A meeting of the **REGENERATION AND PLANNING COMMITTEE** (Quorum – 3)
will be held at Myddelton House on:

**PLANNING CONSULTATION BY THE
LONDON BOROUGH OF TOWER HAMLETS**

SITE AT NORTH EAST OF ATLANTIC COURT, JAMESTOWN WAY, LONDON

Presented by Head of Planning

Site at North East of Atlantic Court, Jamestown Way, London

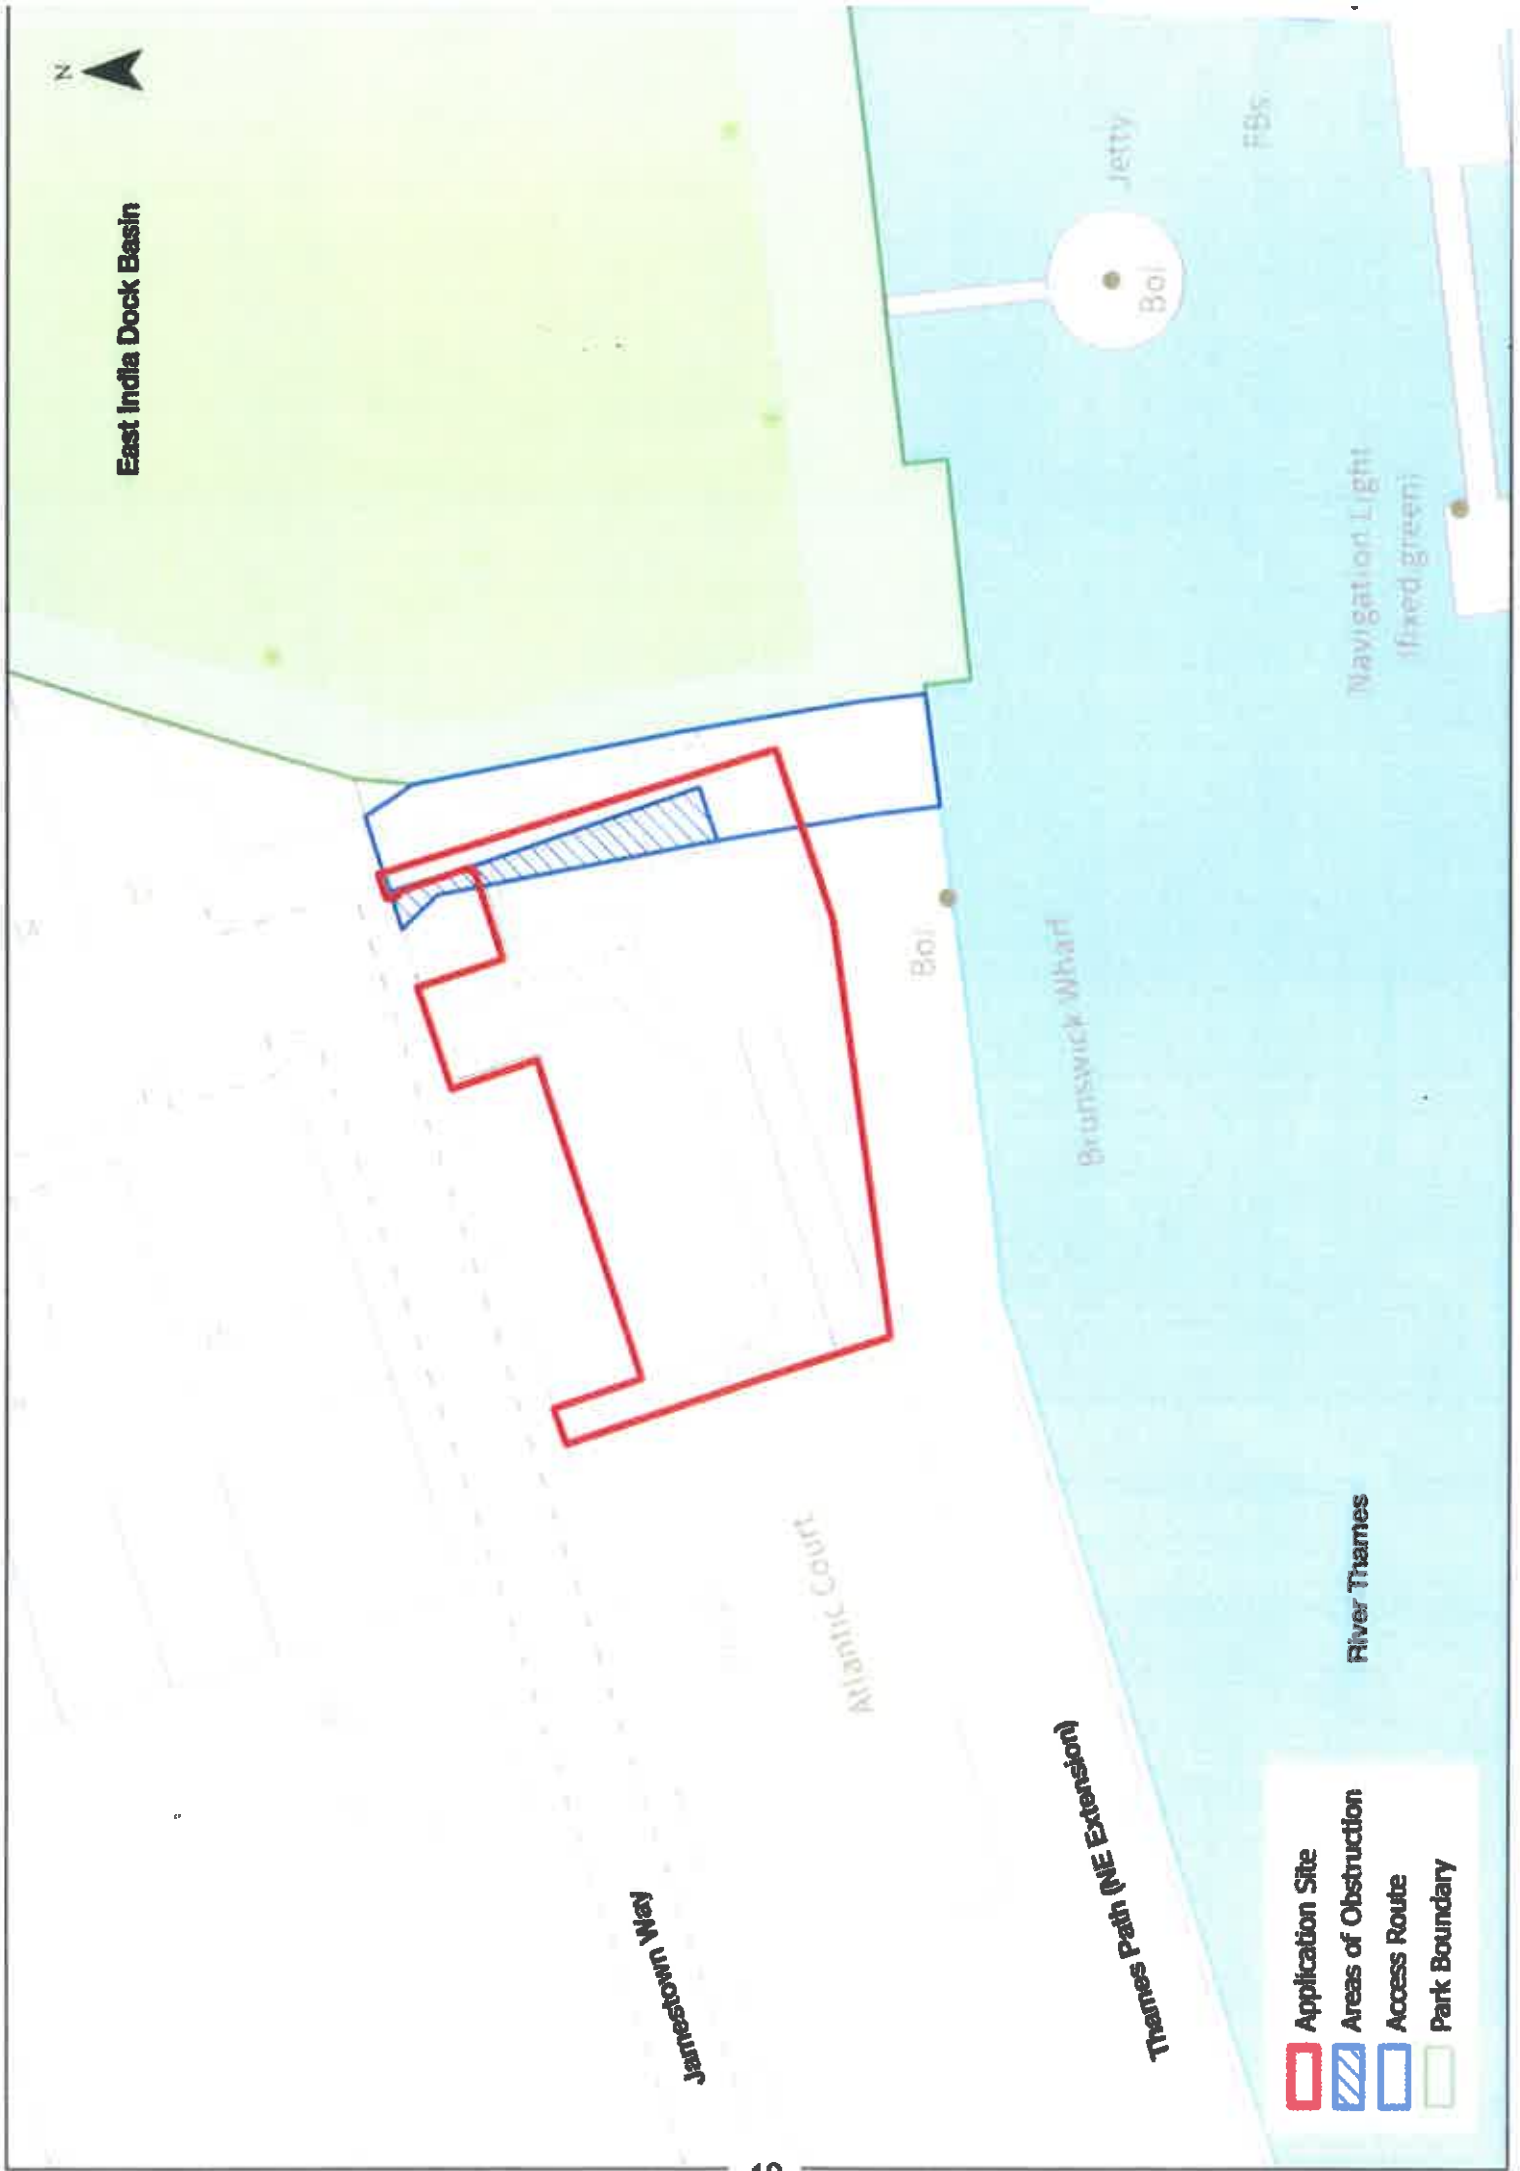
- 1 The application site lies outside but adjacent to the Regional Park, immediately west of East India Dock Basin (EIDB). The site comprises a small and broadly rectangular parcel of land (0.0538ha) which borders the northern bank of the River Thames, adjacent to the Thames Path. The main access to the site is from the north via Jamestown Way. The site is occupied by a single round building in the south east corner with a pitched cylindrical roof known as the Rotunda Building. Attached and to the north of this building is a flat roof extension situated adjacent to eastern boundary of the site. The Rotunda Building previously functioned as a residential marketing suite for the adjoining Virginia Quay development, (a commercial use) and is understood to have been vacated in 2022. A small (321sqm) landscaped public garden adjoins the site. This green space includes 5 no. existing trees, low level walls and hedges and seating. Immediately to the west of the 'garden area' is the five storey Atlantic Court apartment building. Please refer to the Plan at Appendix A to this report.

South Facing Elevation

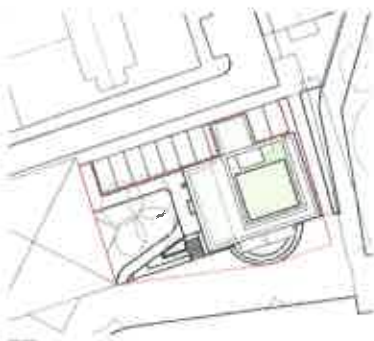
- 10 The Planning Statement explains that the design of the new building draws upon the architectural and historical elements within the area. The plinth at the base of the building encloses the new commercial unit and entry points into the building and at the upper levels the proposed openings follow a grid pattern extending up from the ground floor plinth. This grid pattern is then infilled with lighter stone and textured panels to add contrast to the buildings appearance. Further articulation of the building façade is achieved through use of metal framed windows and doors and use of metal balustrade in a complimentary muted tone. Please refer to images extracted from the Design and Access Statement (DAS) at Appendix C to this report.

- 25 The recent amendment to the choice of materials and colour palette is noted and considered acceptable. Opting for a pale buff coloured palette will enable the proposed building to respond to and sit as part of the existing residential area. The positioning of balconies on the southern and front elevation is also preferred in order to minimise disturbance to wildlife and habitats within EIDB.

Site at North East of Atlantic Court, Jamestown Way, London
 Illustrative Landscape Masterplan
 14th December 2022 Scale 1:100 @ A1
 BD 0918 SD 802 804

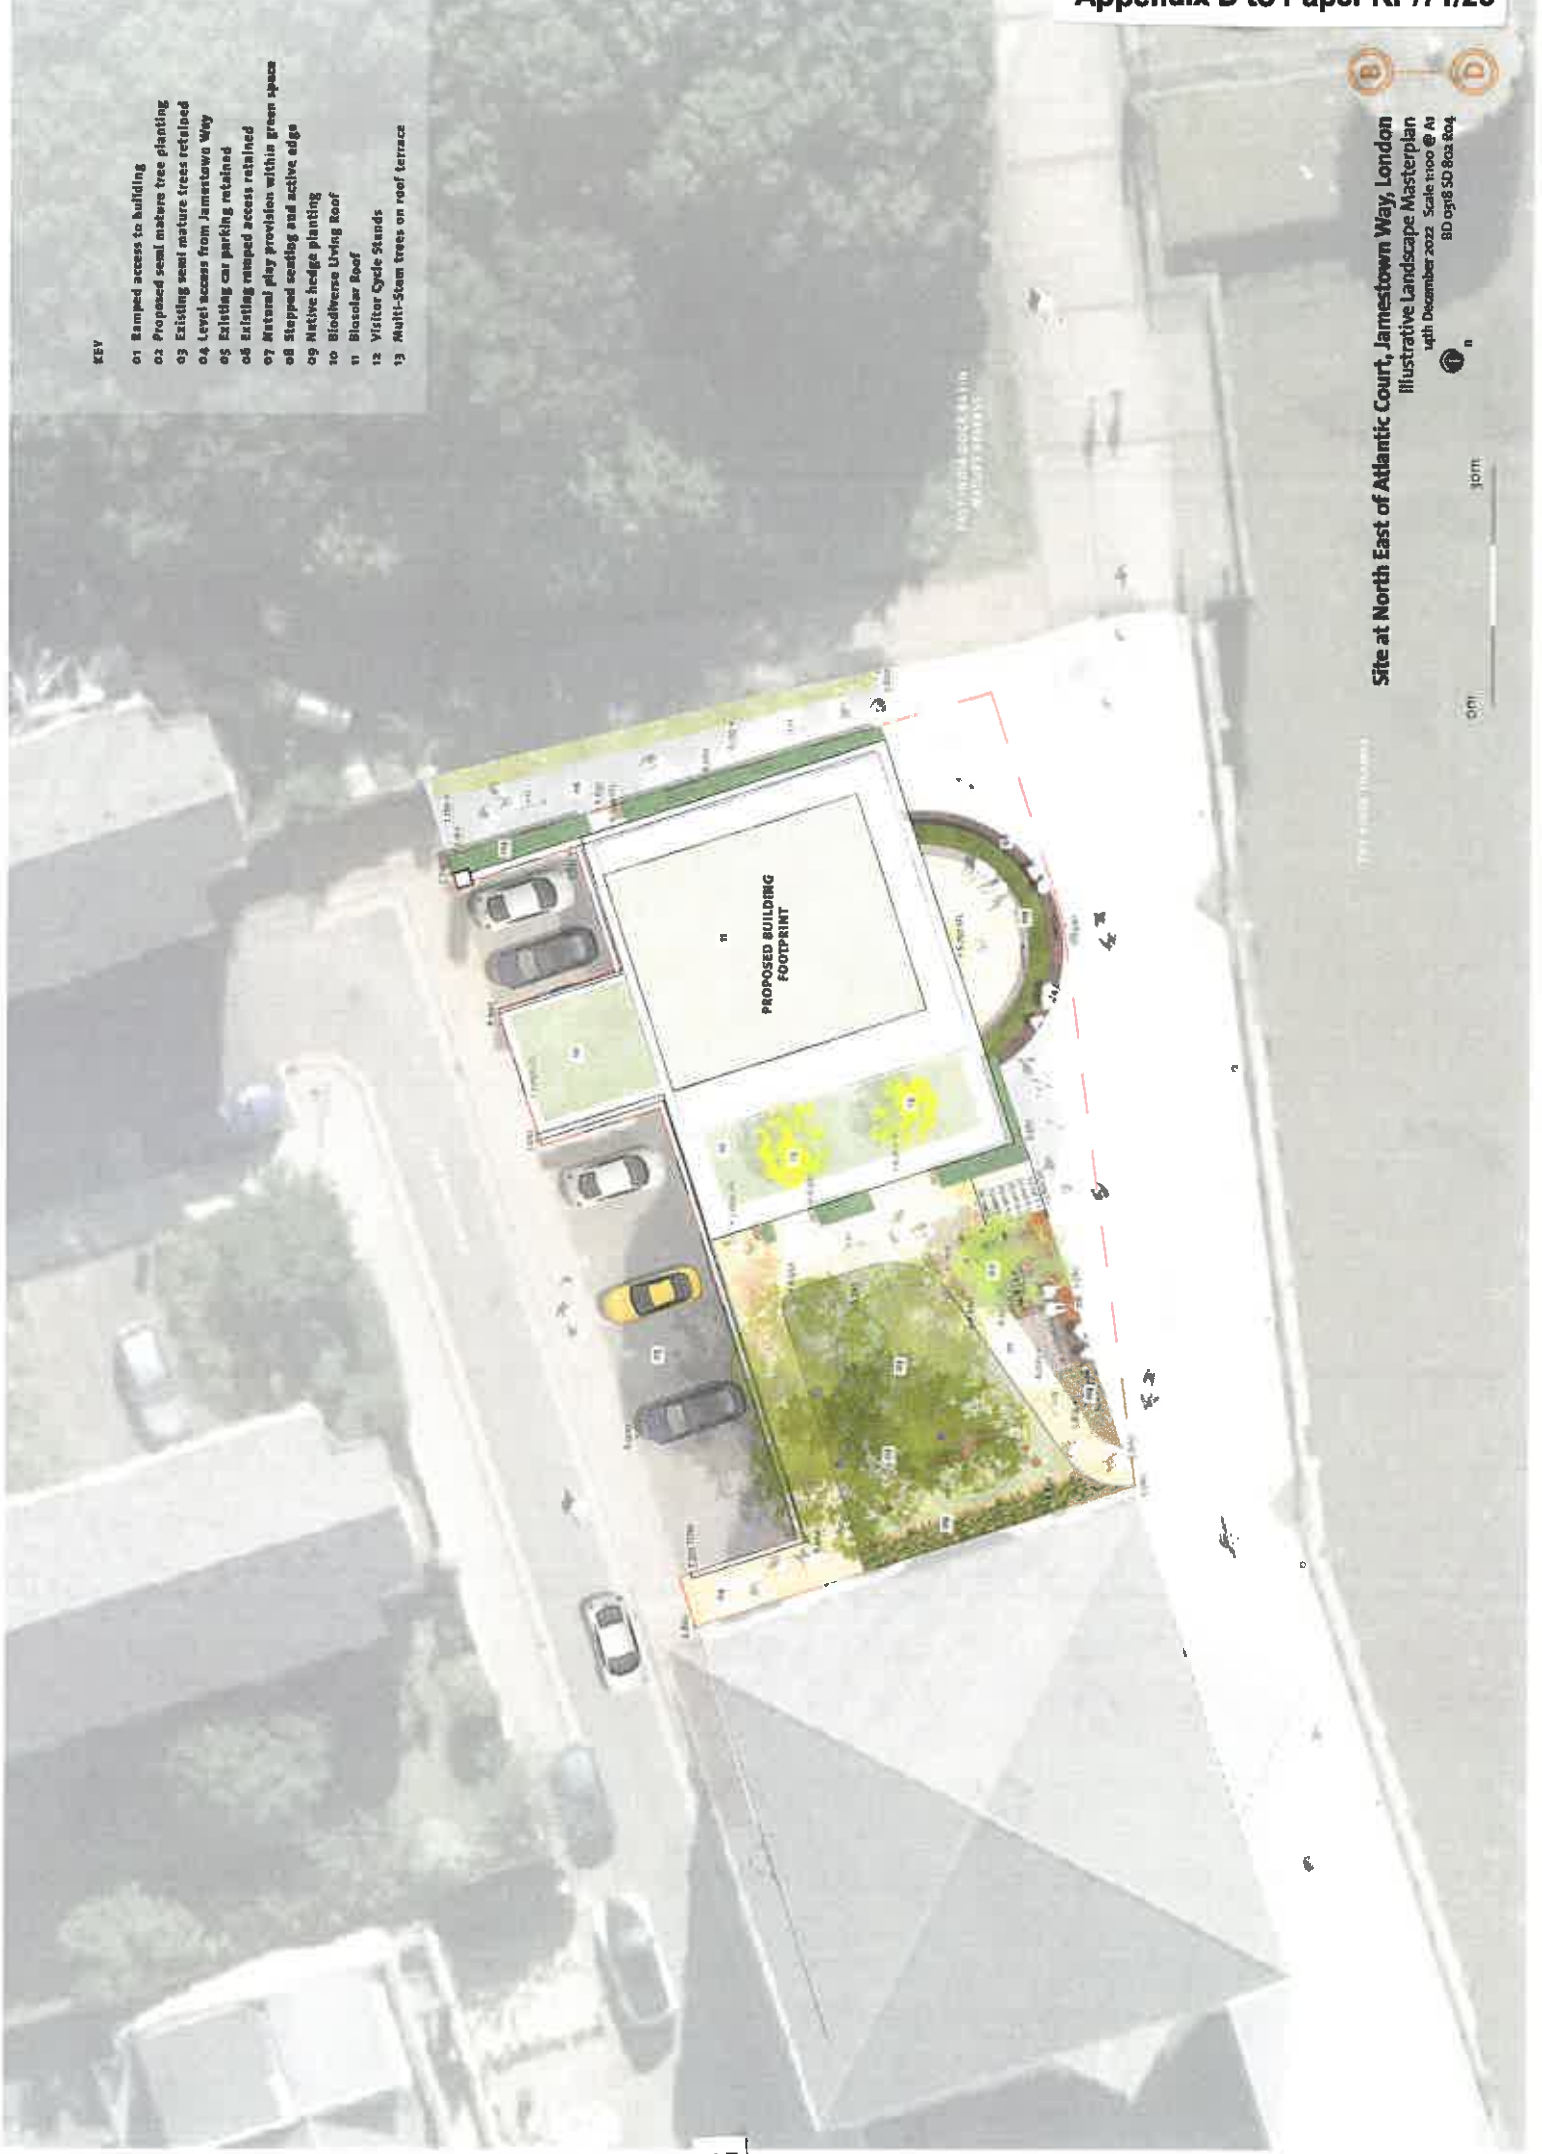
- 28 The wider impacts from construction phases are also likely to be an issue for EIDB and a Construction and Ecological Management Plan should be produced as recommended by the PEA. This will need to detail avoidance and mitigation measures to cover matters such as noise, dust, pollution and contamination for example as a result of surface run-off. Opportunities for biodiversity enhancement on site are set out within the PEA and these are supported, for example a biodiverse green roof on the building (which is shown in the DAS), inclusion of native species rich hedgerow, also indicated on the landscape

- 29 The reconfigured open space will deliver 87sqm of useable green space, a net uplift of 2sqm. The design of the open space is an improvement on the existing, with a much more inviting relationship with the riverside path and the incorporation of natural play space and more biodiverse landscaping. This will serve both residents and the general public. Whilst it is clear that some of the new residents will be using EIDB for informal recreational purposes the small scale (approx. 30 new residents) of the development is unlikely to substantially increase footfall within EIDB, given the existing residential context.
